Subject: Dana Point Marina Rehabilitation Project
Dana Point, California

RESPONSE TO OCPW REVIEW COMMENTS

We are pleased to present the following letter responding to comments received by Orange County Public Works (OCPW). For our use we were provided OCPW comments pages 23 to 33 (not dated).

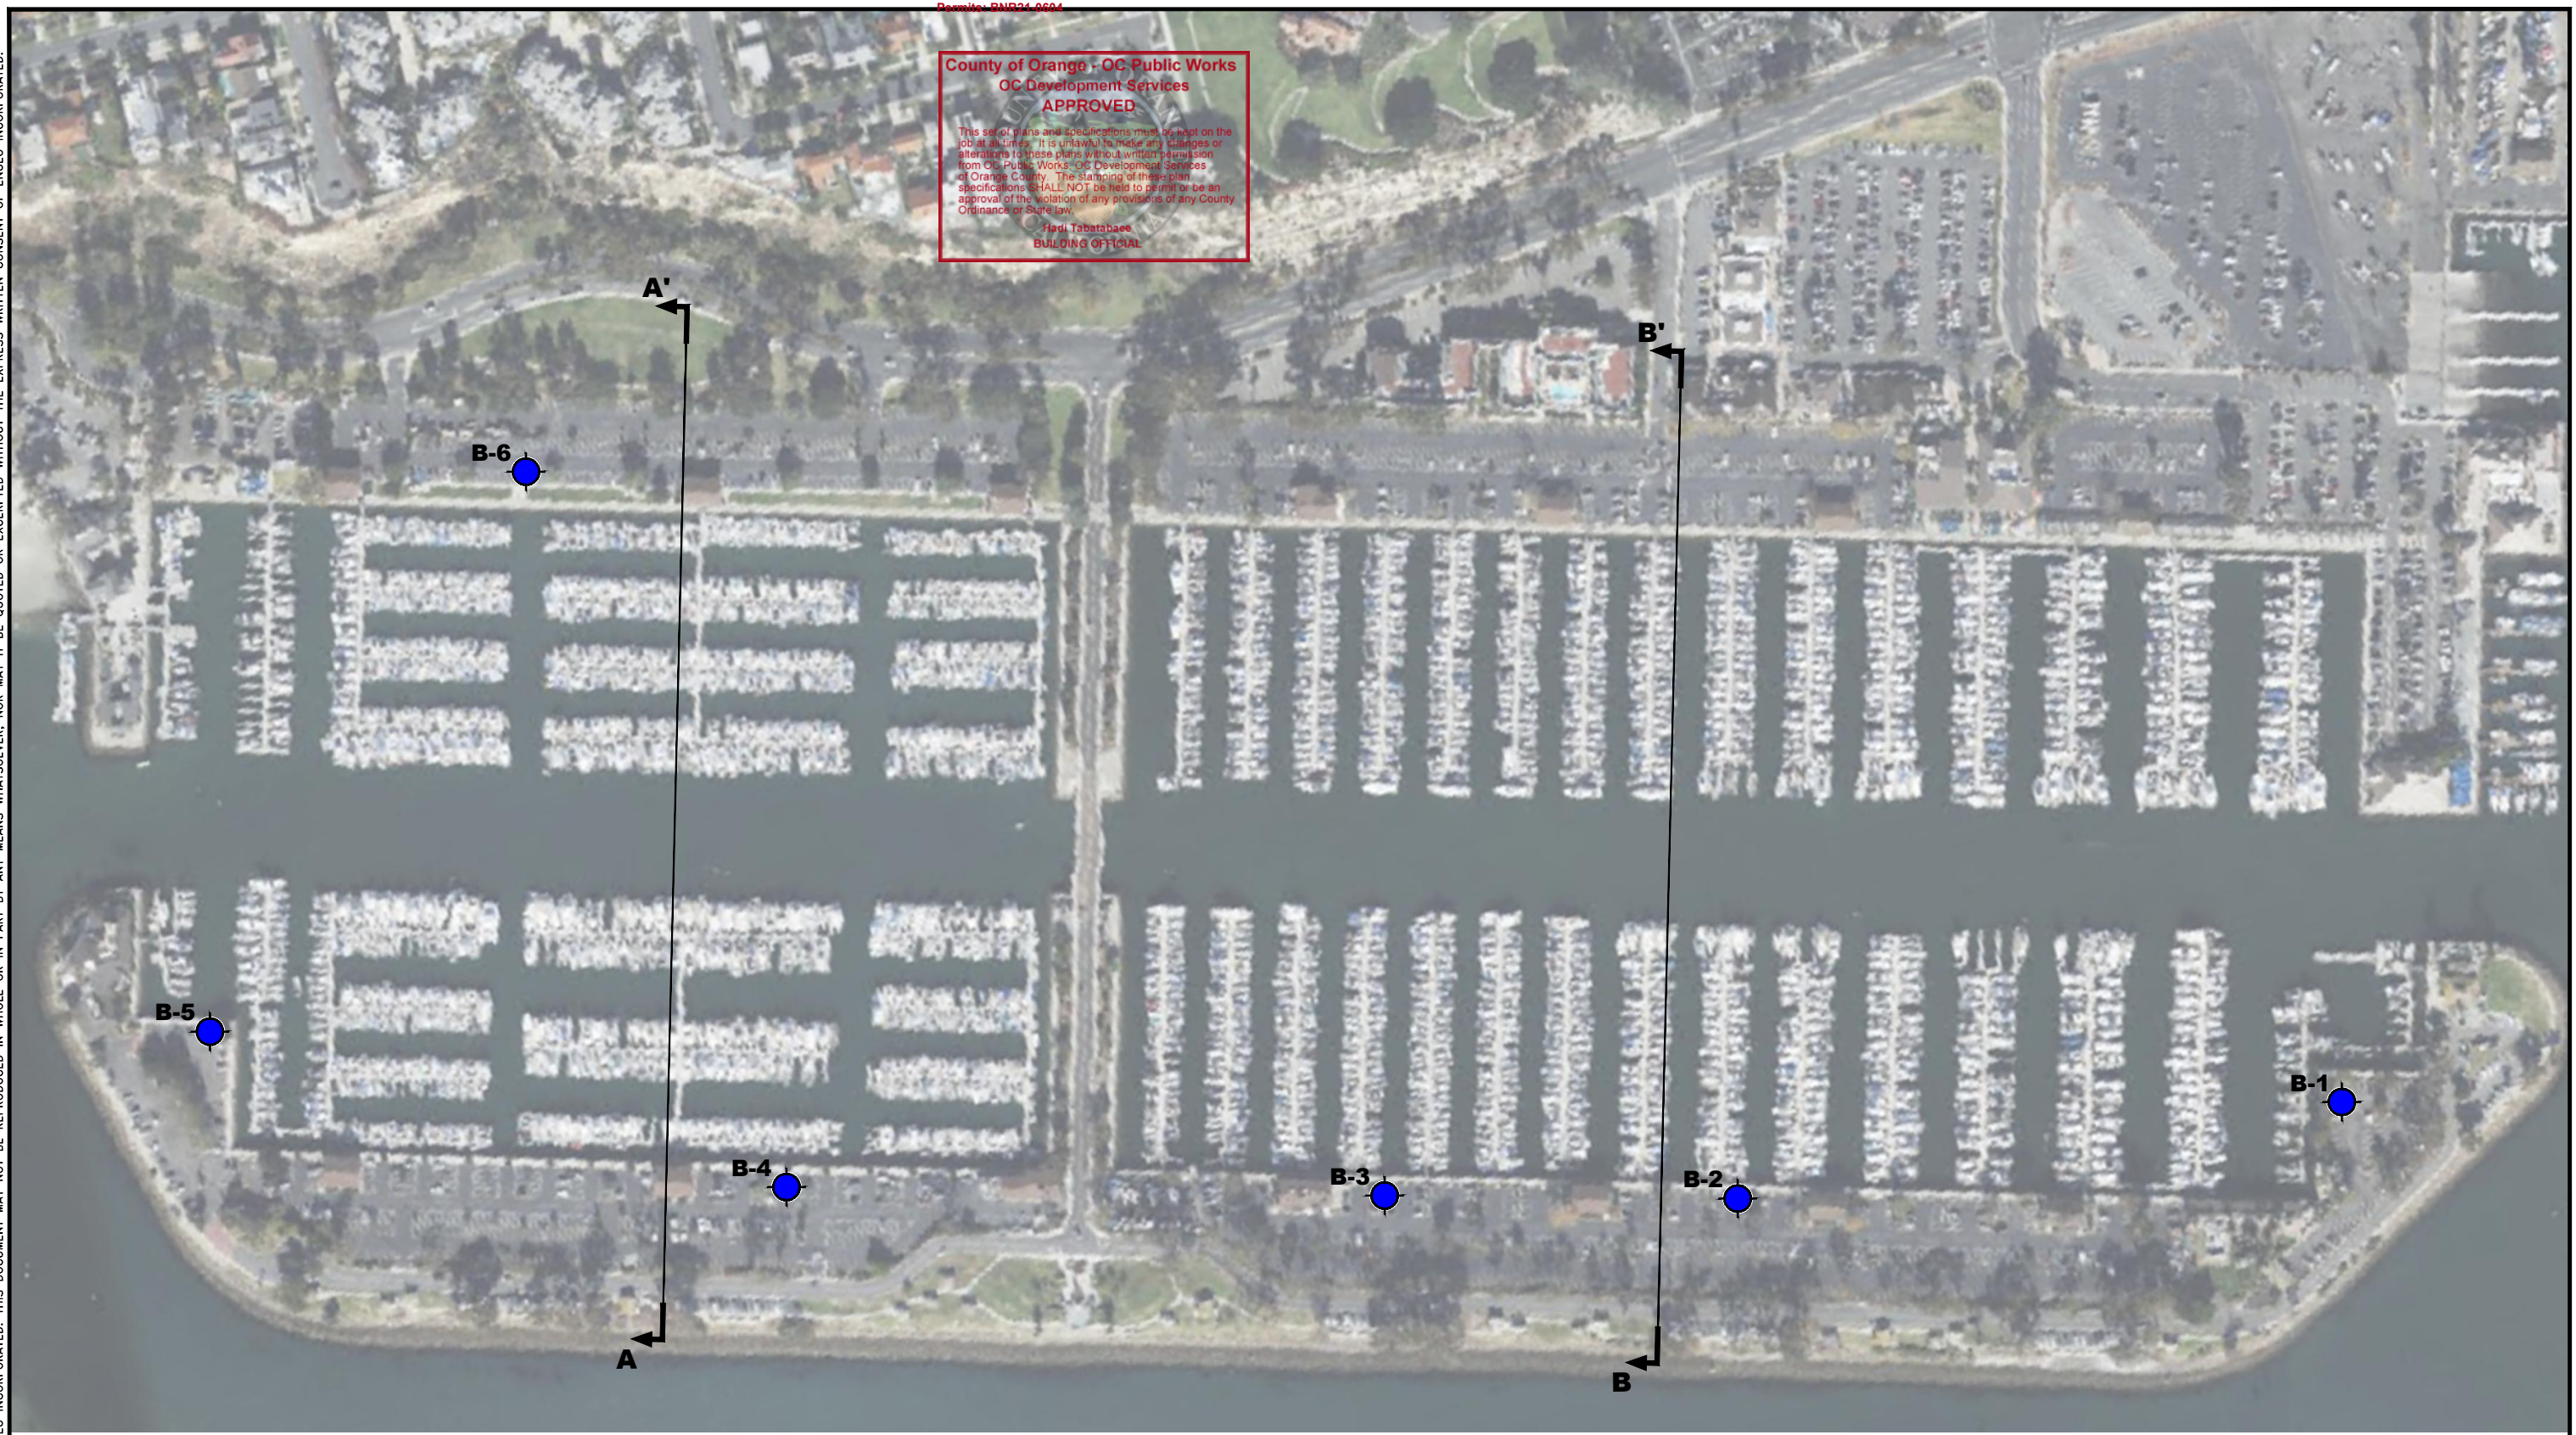
Comment No. 3.001

Geotechnical consultant must review the Dock Plans submitted to the County that will be utilized during construction of the project and provide additional recommendations as necessary. The approved dock plans and applicable details must be reviewed and signed/stamped by the geotechnical engineer and engineering geologist prior to permit issuance. 2nd Submittal Review Comment: This comment will be marked as "Satisfied" upon confirmation of plan check completion/approval and geotechnical signed/stamped approved plans.

See revised drawings. ENGEO reviewed the drawings and sealed sheet PE1.

PROJECT NO.: 19026.000.001	FIGURE NO. 3
SCALE: AS SHOWN	
DRAWN BY: CC CHECKED BY: JJT

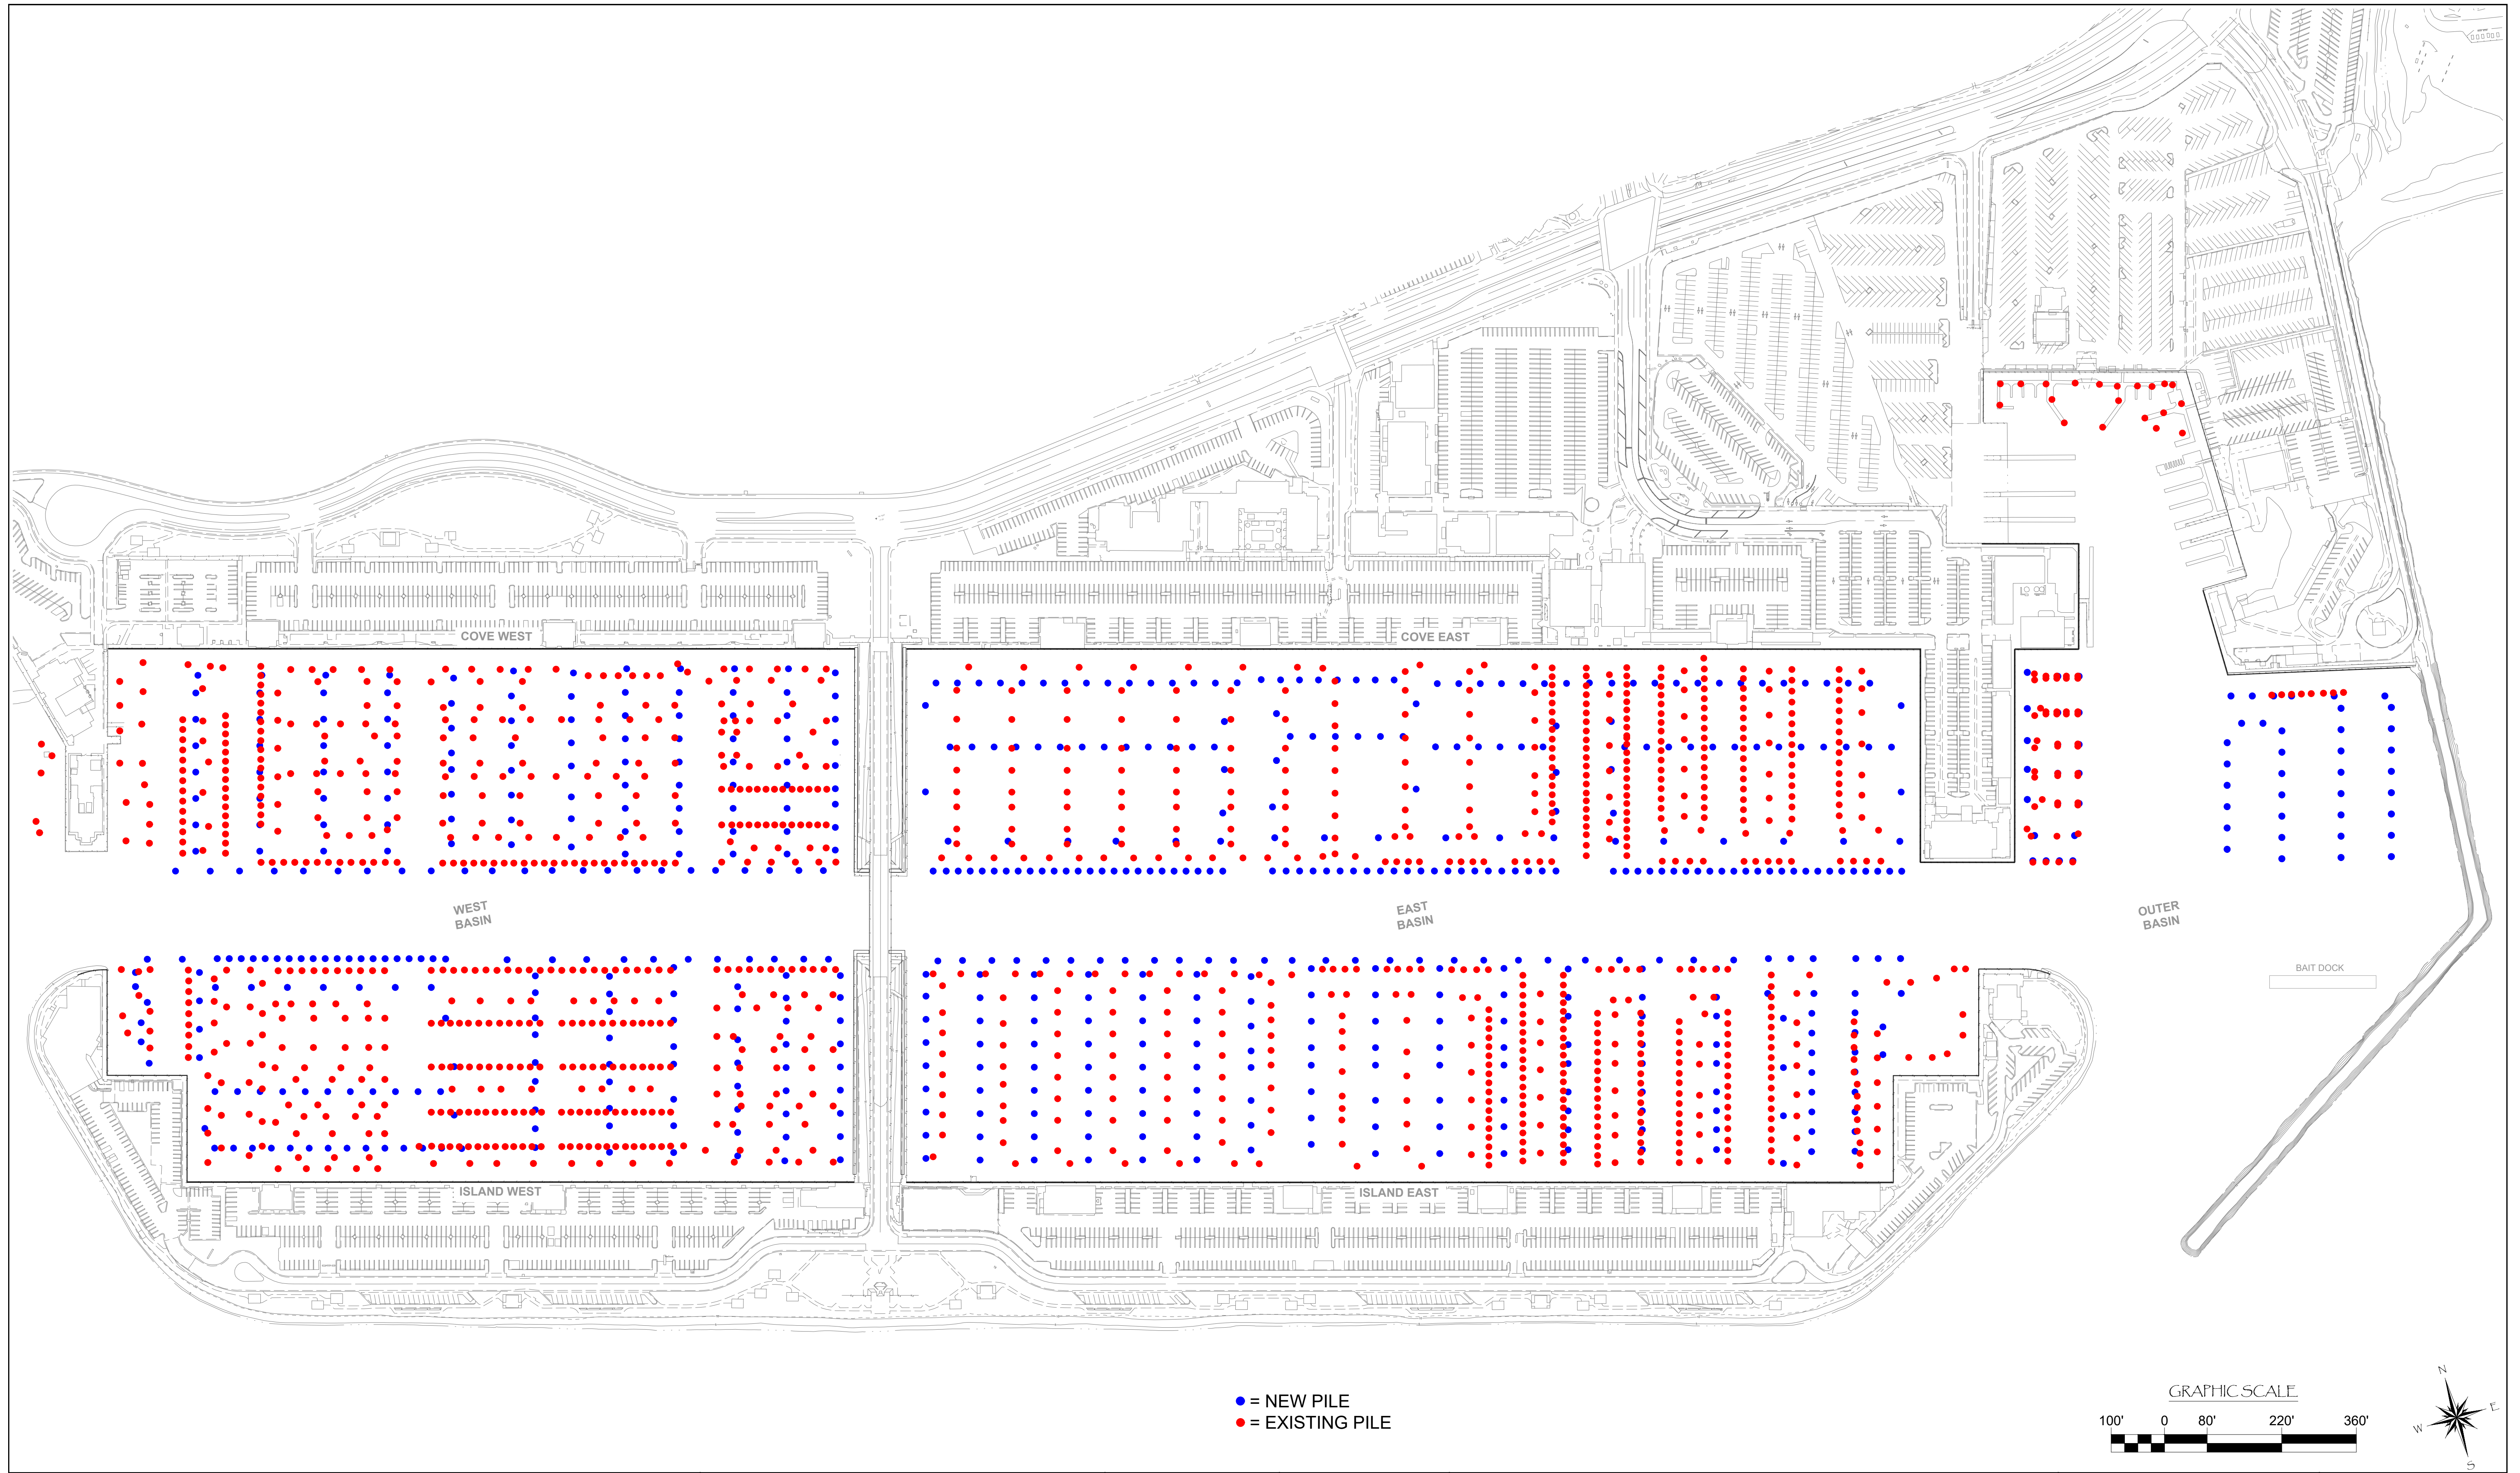
Comment No. 3.024

Update Exhibit 3.2.2-1 from the submitted ENGEO report dated 2/23/22 to indicate typical location of existing piles to be removed (or abandoned in place if applicable) with respects to the proposed new piles. Provide additional geotechnical recommendations as necessary.

Supplemental plan showing proposed piles and abandoned piles has been attached for reference. ENGEO provided a consideration with reference to pile abandonment Section 3.2.3. If piles to be abandoned in place have a distance less than 1 foot as discussed in Section 3.2.3, pull testing should be performed on the subject pile to confirm lateral performance during construction.
